Name Of Dam: TOMS CREEK DAM
Location: WISE COUNTY, VIRGINIA
Inventory Number: VA. NO. 19510

PHASE I INSPECTION REPORT

NATIONAL DAM SAFETY PROGRAM

NAME OF DAM: TOMS CREEK
LOCATION: WISE COUNTY, VIRGINIA
INVENTORY NUMBER: VA. NO. 19510

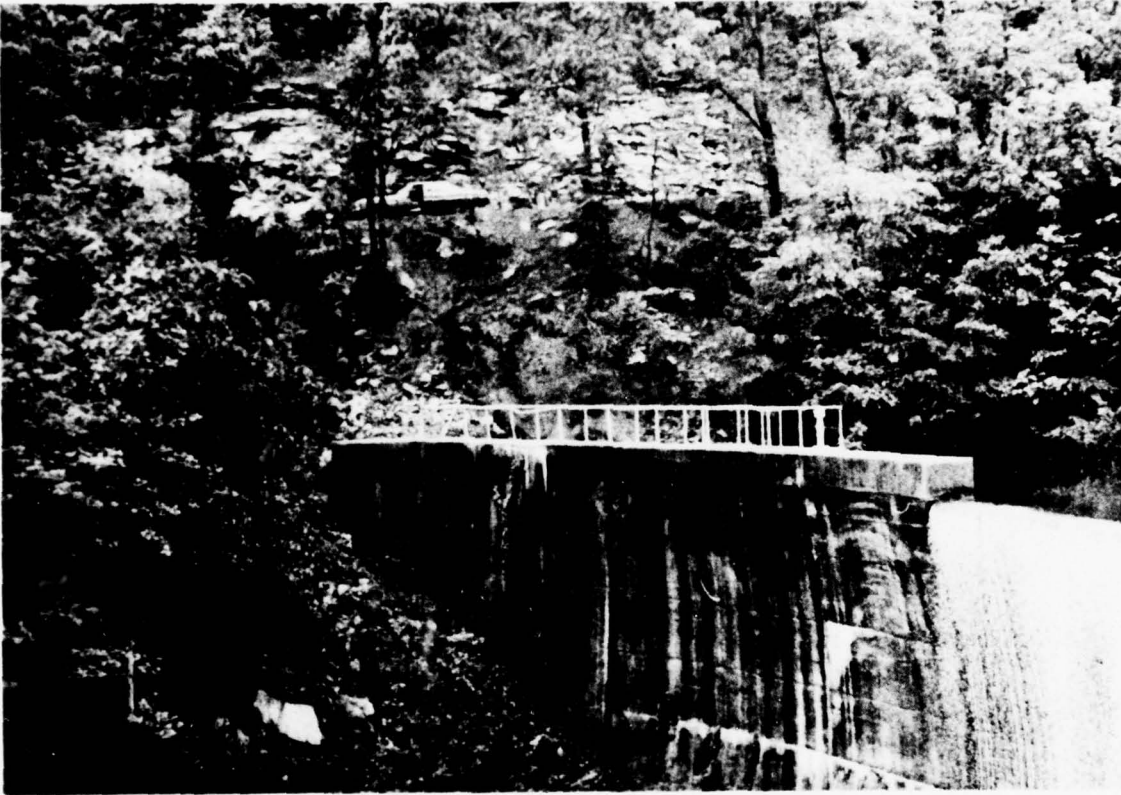
A small area directly above the contact of the dam and right abutment is eroding due to runoff water from a 30 inch CMP highway drain (See Photo No. 2, Appendix II). Erosion is occurring in the form of embankment sloughing.

1.11 Erosion of Abutment Slopes: The only erosion observed is just below the outlet to the drain pipe above the right abutment. Water from one side of the road is diverted under the road, expelled on the right abutment slope and drains downward into the reservoir.

- (3) The highway drainage pipe located above the right upstream abutment should be relocated in order to prevent slope erosion and future damage to the dam.

7.2.3 The drainage pipe located above the right abutment should be relocated. Slope erosion associated with outflow from the pipe has already caused minor damage and we recommend it be relocated within the next six months, as to prevent future damage.
